Kyleakin Pier – Request for clarification of issues relating to Chapter 18 of EIS.

Response to comments made by SNH email 28th December 2016

Scenario 1 TSHD with dredging period of 75 days

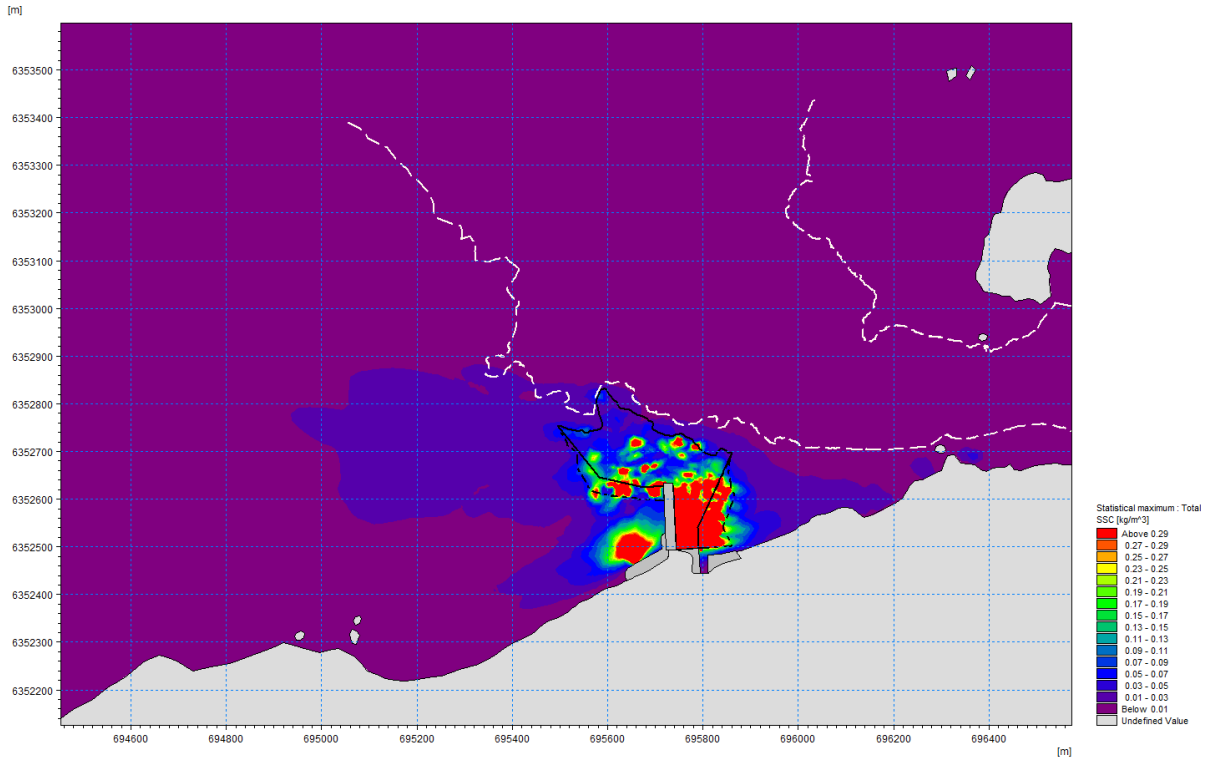
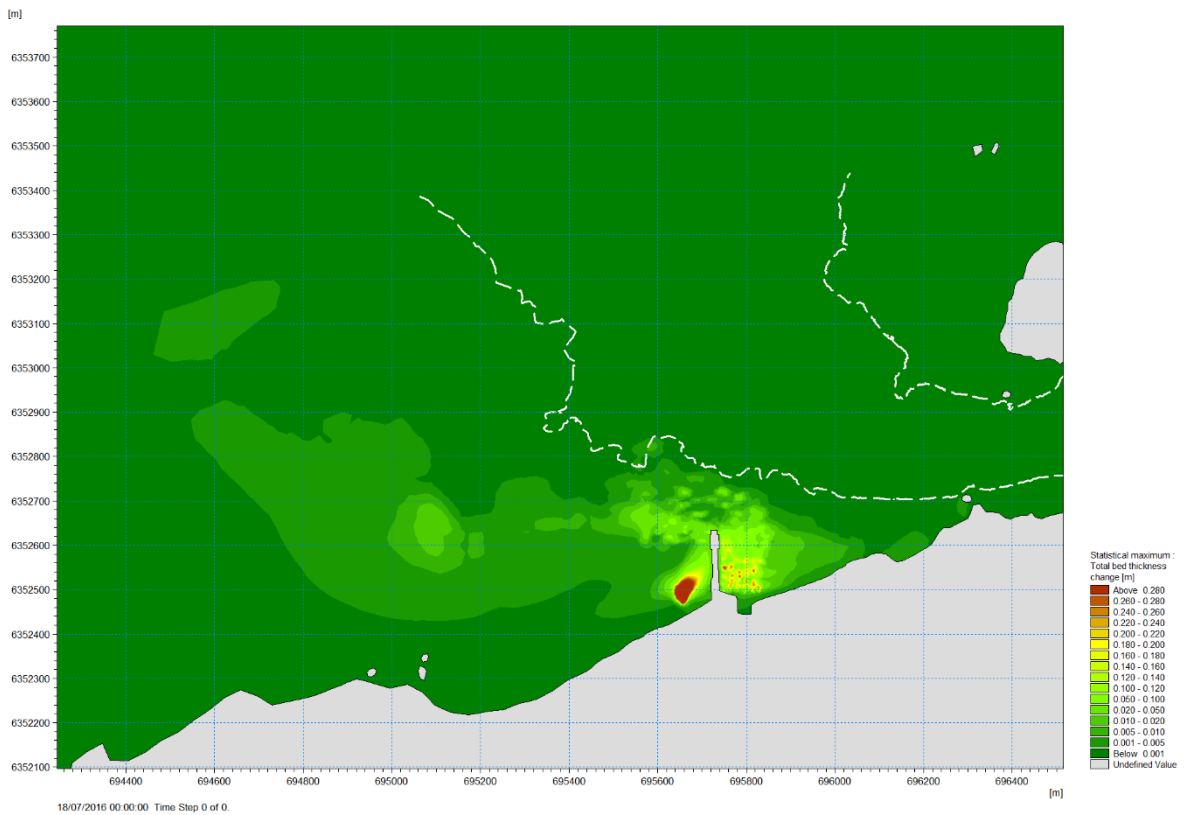
Comment 3

In one of the early drafts of the text for the coastal process chapter we included maximum SSC envelope plots for each of the dredging scenarios but these were excluded from the final version as we have found from previous experience that most non technical people reading the EIA find these plots extremely confusing. For the benefit of SNH we have set these out below together with the maximum bed thickness envelope for each of the dredging scenarios.

The maximum SSC envelop shows the area which is covered by the dredging plume as it moves back and forth with the tidal and wind driven currents over the full period of the dredging operations. The value of the SSC shown in the diagrams are the maximum value that occurs at each point in space at any time throughout the dredging operation even if it only occurs for a very short period of time.

In a similar manner the maximum bed level change envelop plot shows the maximum deposition depth of sediment over the area at any time during the dredging operation even if the material is temporally deposited during say the turn of the tide and is subsequently re-suspended by the increasing tidal flow. A comparison can be made between the maximum deposition depths plot and the deposition depth plot at the end of the simulation to see the areas where temporally deposited sediment has been re-suspended.

The maximum envelop plots for each dredging scenario are shown below: These diagrams may be compared with the mean SSC and the deposition depth at the end of the dredging simulations shown in Section 8 of Chapter 18 of the EIA for each Scenario as follows

It will be seen from the diagrams above and the appropriate figures in Section 8 of Chapter 18 of the EIA that the maximum SSCs which occur over the flame shell beds are low and restricted to a very small part of the flame shell bed area and are of short duration. Similarly the maximum depth of deposition on this small part at the edge of the flame shell beds is very low being less than 2mm and again only occurs for a short time during the turn of the tide. Effectively the flame shell bed area is totally dispersive for the dredged plume material.
